Burlington Design Advisory Board

DESIGN ADVISORY BOARD Tuesday, June 13, 2023 3:00 PM

MEMORANDUM

To: Design Advisory Board
From: Scott Gustin & Garret King
Re: 483 Manhattan Drive
Date: June 13, 2023

A WEST ELEVATION
SCALE: 1/16" = 1'-0"

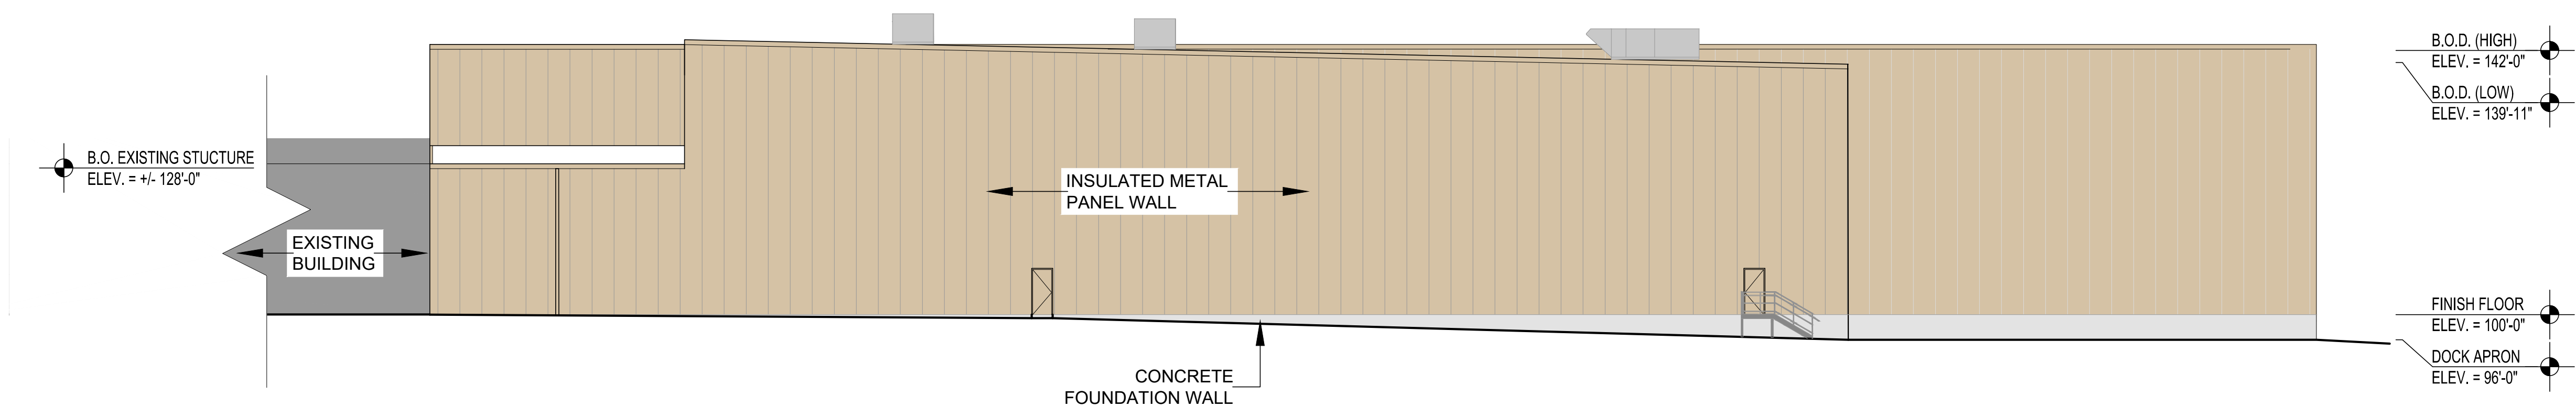
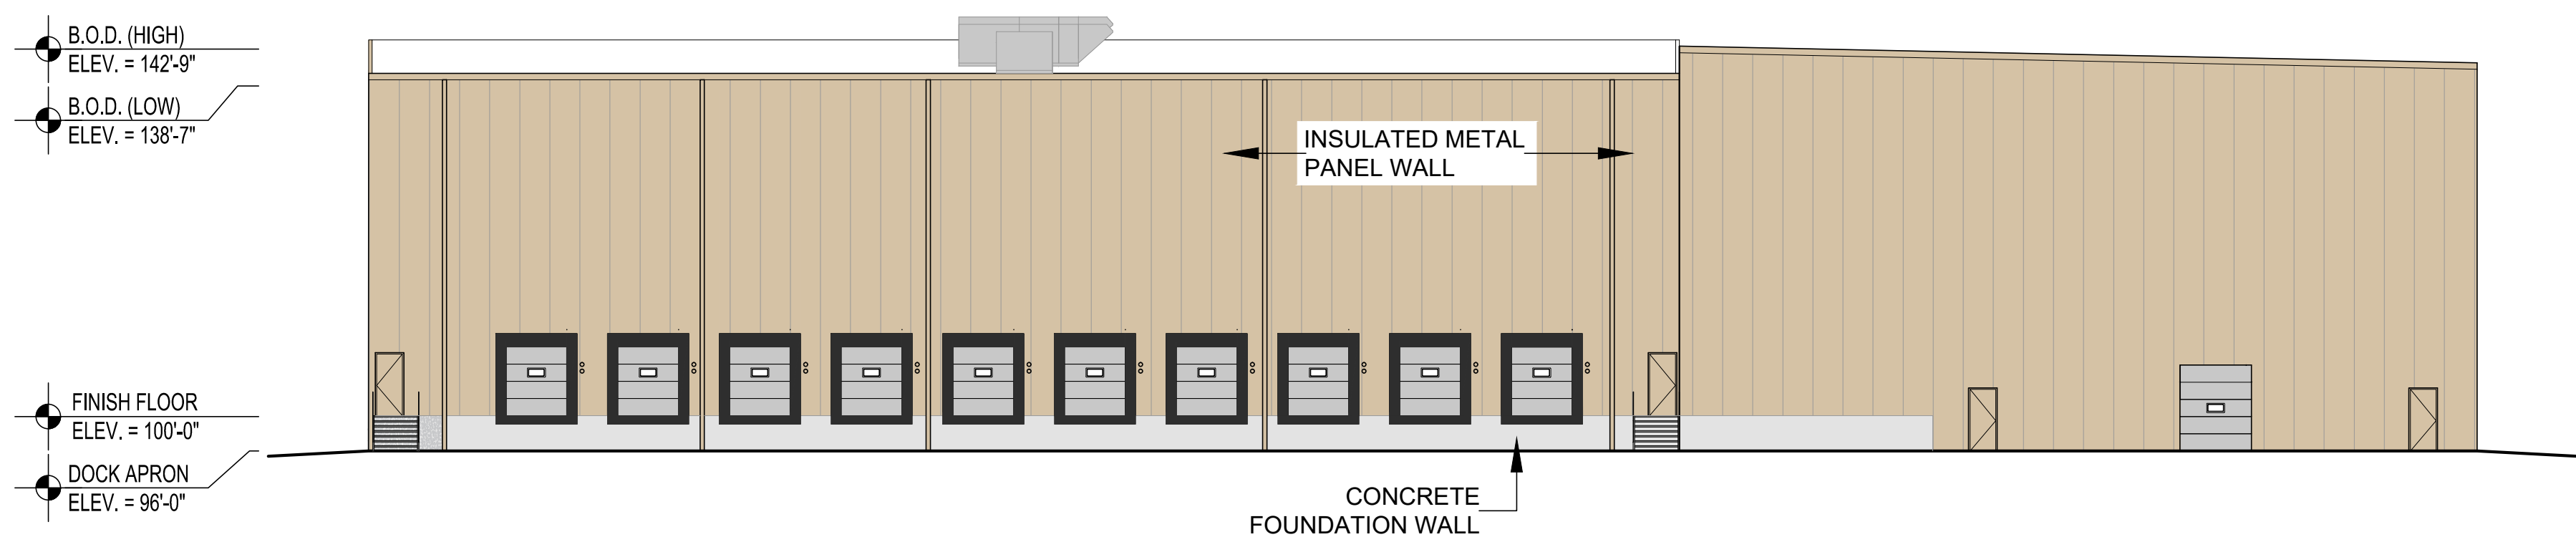
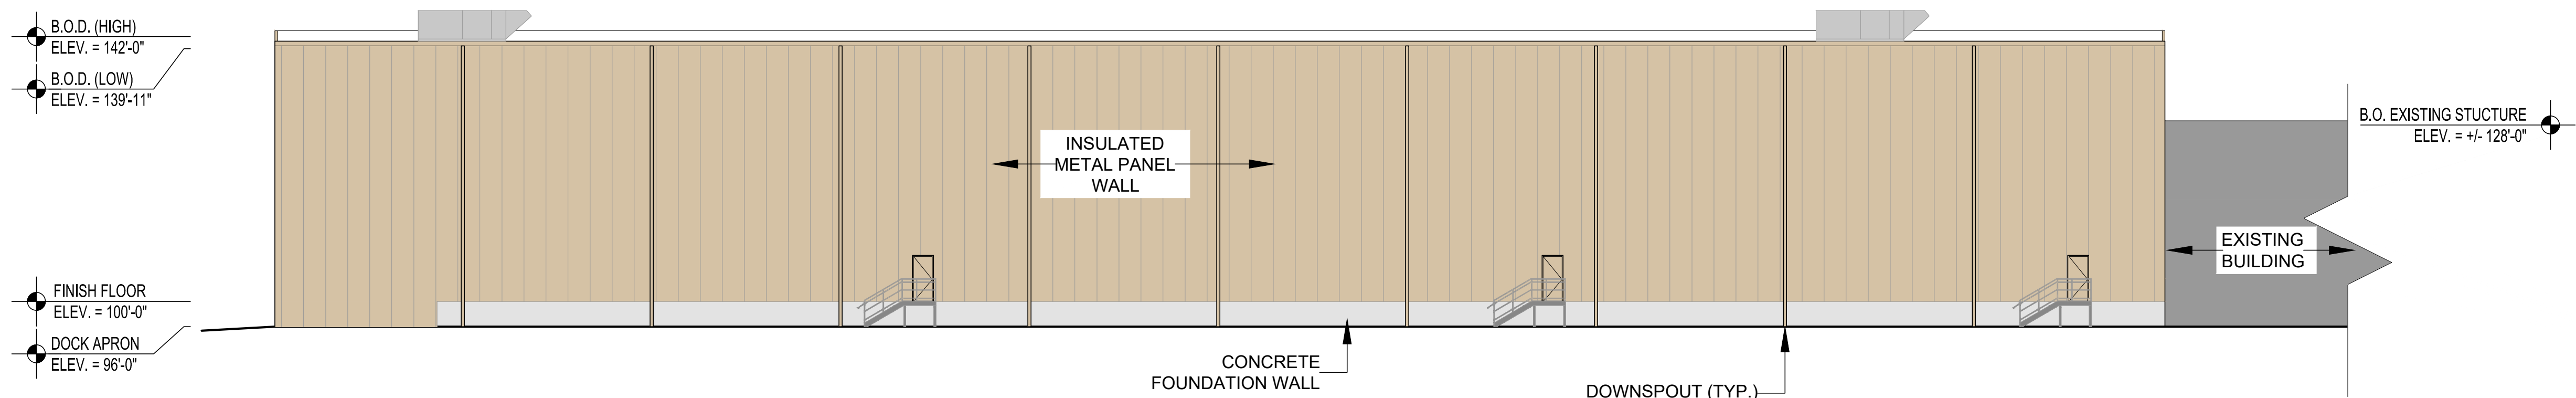
Peripheral green space remains for wintertime snow storage from plowing. Existing sheltered building entries will remain. Several new entries are depicted on the elevation plans and lack any shelter. They are presumed to be emergency exits, but clarification is warranted.

The proposed addition presents a monolithic metal wall to the public street. There is no variation of building materials or plane of the building. There are no architectural features. Except for some external downspouts, the addition presents a large expanse of undifferentiated building wall to the public street. It is understood that this is a commercial manufacturing facility, and some sort of high-style design is not necessary. However, the proposed addition lacks even a minimal attempt at addressing this criterion. All of other commercial buildings along this street incorporate at least balanced fenestration along their entire street frontage. The application narrative asserts that modification of the insulated metal panels may void their warranty. There are myriad ways to provide an active and inviting street edge, even for a food processing facility.

Continued review to address Sec. 6.2.3 (d), *Provide an active and inviting street edge.*

- Provide the boundary survey for the lot merger.
- Clarify purpose of the new pedestrian doorways in the addition.
- Depict bike rack location(s) on the site plan.
- Specify roofing material.
